**Re: Response to EPA Analysis of the *Final Habitat Mitigation and Monitoring Plan*, dated September 12, 2017, EPA Comments October 5, 2017 (Revised November 30, 2017)  
Rosemont Copper Project, Clean Water Act Section 404 Permit, CoE File No.: 2008-00816-MB**

## **RESPONSE TO ENVIRONMENTAL PROTECTION AGENCY (2017)**

**"The Mitigation Proposed by Rosemont Mine  
Will Not Offset Impacts to Waters of the U.S.  
below the Level of Significant Degradation"**

**Exhibit 5. Average-Annual Runoff Regression from Stone et al. (2008)**

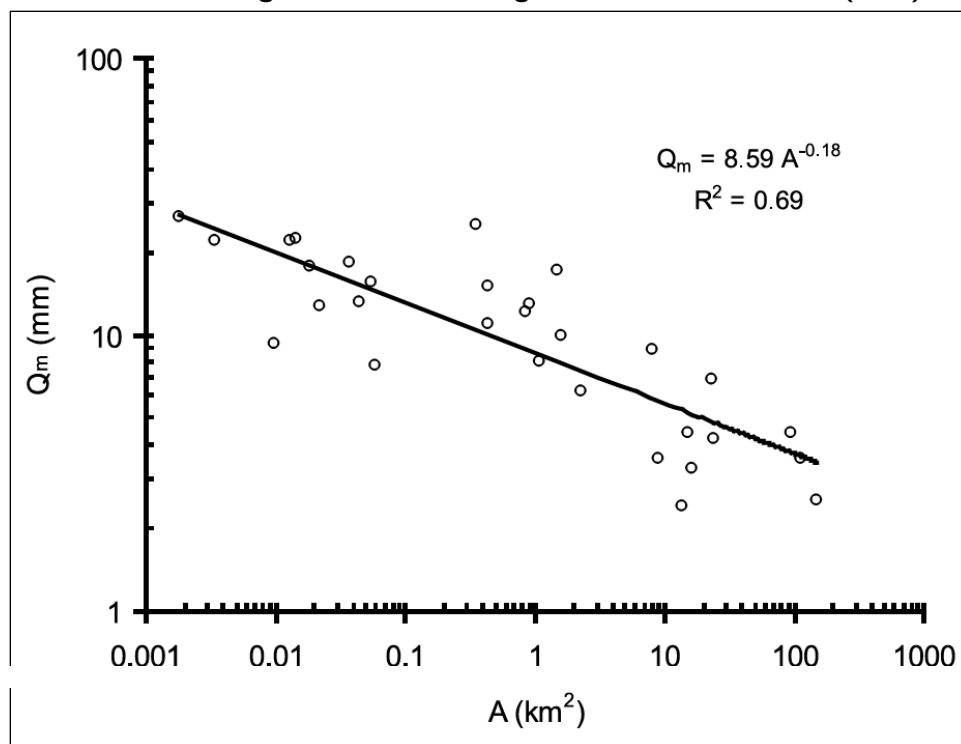
The EPA (2017) has expressed concern relating to the revised pre-mining and post-mining estimates and has questioned the validity of the methodology: “*The estimates of average-annual runoff rely on an inappropriate model/regression equation. The regression equation can only apply to the limits of the data. A continuous simulation model with daily time steps would be more appropriate. A regional model such as a SWAT-based model that is localized with smaller resolution grids is an example of such an approach.*” This observation is flawed, however, because it is not the resolution or time step of the model that is of primary importance, but rather the relative comparison between the modeling results (i.e., modeled pre-mining flows vs. modeled post-mining flows). The EPA’s assertion, that a continuous simulation model with daily time steps is

The EPA (2017) also comments that the runoff regression methodology used does not consider stock pond capacities, and that if pond capacities are taken into account, the runoff regression methodology will demonstrate that the ponds do not have sufficient capacity. The EPA is correct, in that the stock ponds will not have sufficient capacity to retain runoff volumes estimated by the runoff regression methodology. However, it has recently become apparent, based on nine years of continuously recorded streamgauge data at the USGS gaging station located immediately downstream of the Rosemont watershed in Barrel Canyon at SR 83 (USGS 09484580 BARREL CANYON NEAR SONOITA, AZ; referred to herein after as the USGS SR 83 streamgauge), that the runoff regression methodology originally employed to estimate average-annual runoff is, in fact, extremely conservative, and significantly overestimates runoff volumes emanating from the Project watershed area. That is, recent runoff data, recorded for the past 9 years (from 2009 through December 31, 2017) at the USGS SR 83 streamgauge indicates that the average-annual runoff (on a calendar-year basis) is approximately 124.4 AFA. The minimum value recorded was 34.0 AFA (in 2009), and the maximum value recorded was 260.8 AFA (in 2017; includes provisional data). Thus, the regression methodology significantly overestimates actual annual runoff measurements by more than 11 times ( $11.3 = 1,404 \text{ AFA} / 124.4 \text{ AFA}$ ). Given the lack of data from this streamgauge at the time the original regression equations were developed in 2010, it was necessary to use data from regional USGS-gaged watersheds. As such, the original regression equation analyses significantly overestimated the amount of flow discharging from the Rosemont watershed.

However, before such a demonstration is presented, the following additional information is provided regarding the actual runoff that discharges from the Rosemont watershed. In 2008, Stone et al. (2008) collected and analyzed average-annual runoff volumes that were collected from streamgages on the Walnut Gulch and the Santa Rita Experimental watersheds, both located in southern Arizona and in close proximity to the Rosemont watershed. Using the runoff data, which was collected as early as the 1950s, Stone et al. (2008) developed a regression equation to estimate average-annual runoff based on watershed area. This equation is presented in **Exhibit 5** and compares average-annual stormwater runoff per unit area to the size of the catchment area.

**Exhibit 6. Three (3) Year Total Annual Precipitation Variability across the Rosemont Project Watershed**

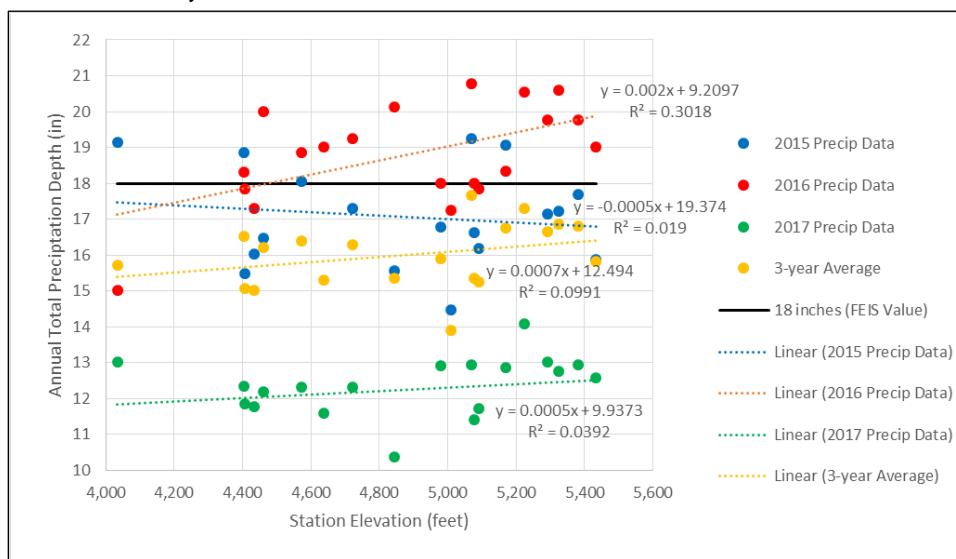
The EPA (2017) also provides the following comment with regard to precipitation across the site: *“The model parameterization for average annual rainfall (i.e., 18 inches) in Equation 2 is likely significantly less than values at the higher-elevation stock pond locations.”* Here, the EPA is alluding to a presumed relationship between elevation and precipitation at the Rosemont Project, where higher elevation theoretically equates to higher precipitation. While that orographic relationship may exist on a regional scale, it is less evident on a smaller watershed scale, such as for the Rosemont Project where the watershed is a maximum of 5.5 miles wide (measured from the southwest corner of Wasp Canyon sub-watershed to the USGS SR 83 streamgage).

**Exhibit 6** shows the total annual rainfall (recorded at each of the 21 gages) plotted against the gage elevation. Best fit linear regression trend lines (and equations) are also plotted. Although there are only three years of data available (from May 2015 through December 2017), four important conclusions can be made: (1) there is a high year-to-year variability in total annual precipitation (e.g., in 2016 the total average precipitation throughout the site was about 18.8 inches, but only 12.2 inches in 2017); (2) there does not appear to be any meaningful relationship showing an increase in total annual precipitation with elevation (e.g.,  $R^2$  values are all less than 0.3, which indicate that the linear regression equations do not

represent any meaningful relationship); (3) there is high variability in total annual precipitation across the watershed (e.g., in several cases, gages at lower elevations had higher precipitation values than gages at higher elevations); and (4) the average value of 18 inches (used in the FEIS) is representative, and likely a conservative estimate, for the site-wide average. Thus, the average-annual rainfall value of 18 inches is valid and representative for the entire Rosemont Project watershed.
